SERVICE BULLETIN

No. 496

Piper Aircraft Corporation

Stabilator Balance Weight Tube Replacement.

Detail "A" :

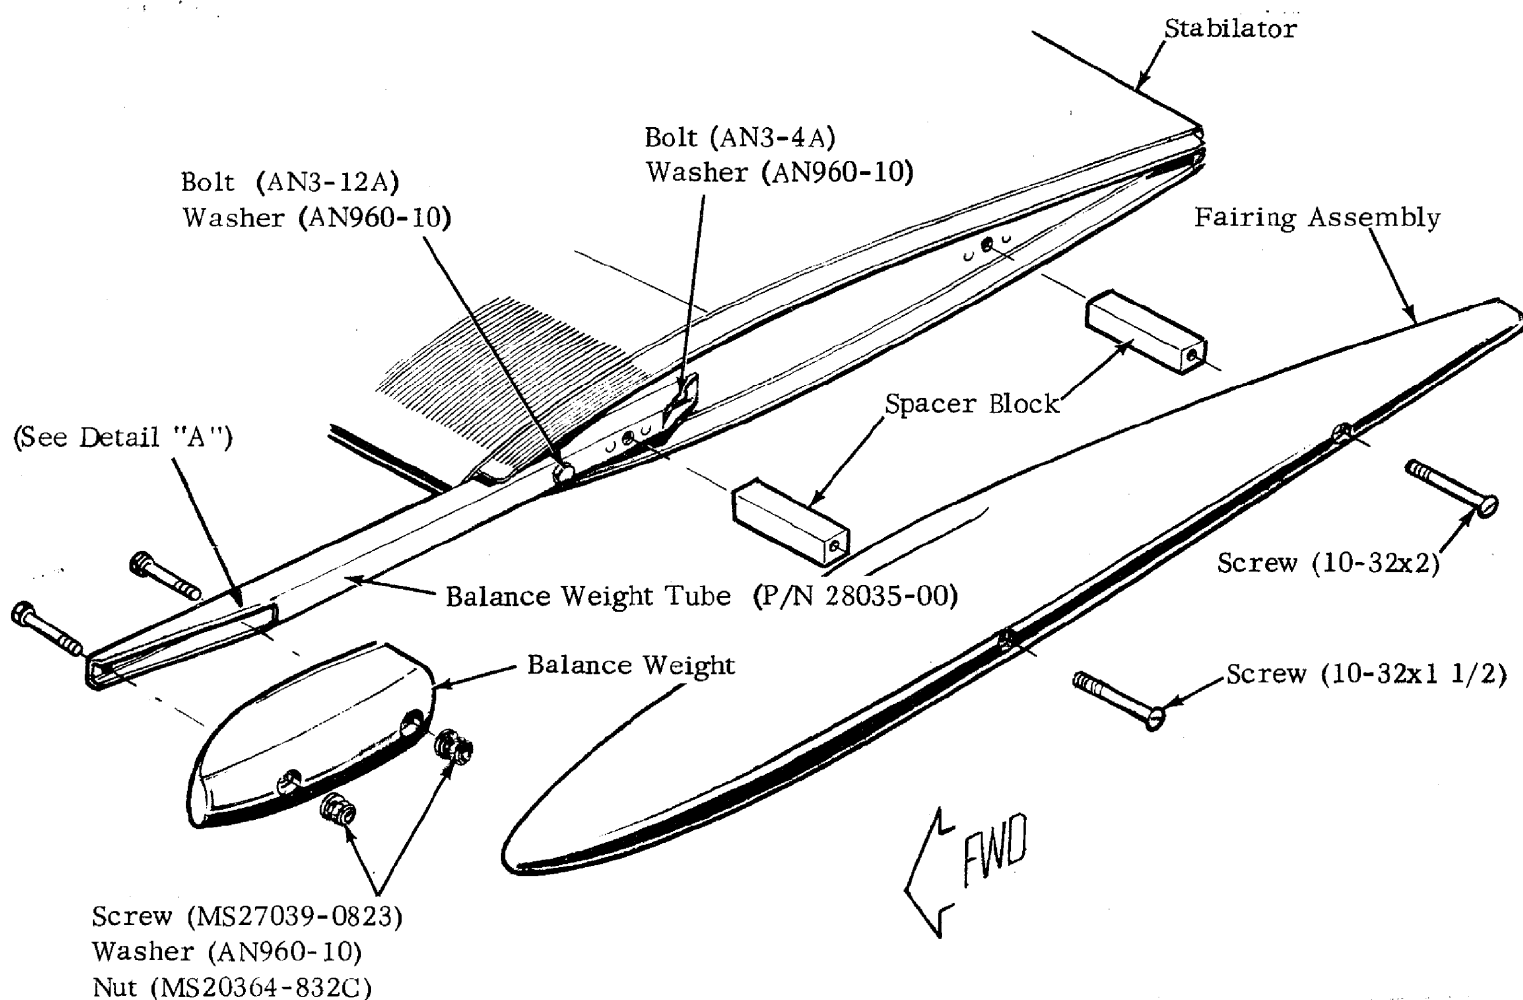
Piper Service Letter No. 687 dated June 19, 1974, announced the availability of Stabilator Modification Kit Piper Part Number 760 747 for the above referenced aircraft. Recent factory testing indicates that cracks may develop in the stabilator balance weight tube assembly (part number 28035-00, supplied with the above referenced modification kit) in the corners of the balance weight cutout.

Previous Tube - "squared" corners

New Tube - rounded cutout

This service release provides material to replace the stabilator balance weight tubes on aircraft that have had stabilator modification kit, Piper part number 760 747 previously installed. New stabilator balance weight tubes are provided and are redesigned with a reshaped balance weight cutout (radius cut corners) to preclude corner cracks.

1. Remove fairing assembly and balance weight from left and right stabilators.
2. Remove existing balance weight tubes and install new tubes P/N 28035-00.
Torque bolts to 20-25 inch pounds.
3. Reinstall balance weight and torque screws to 7-9 inch pounds.
4. Reinstall fairing assembly.
5. Make appropriate log book entry.
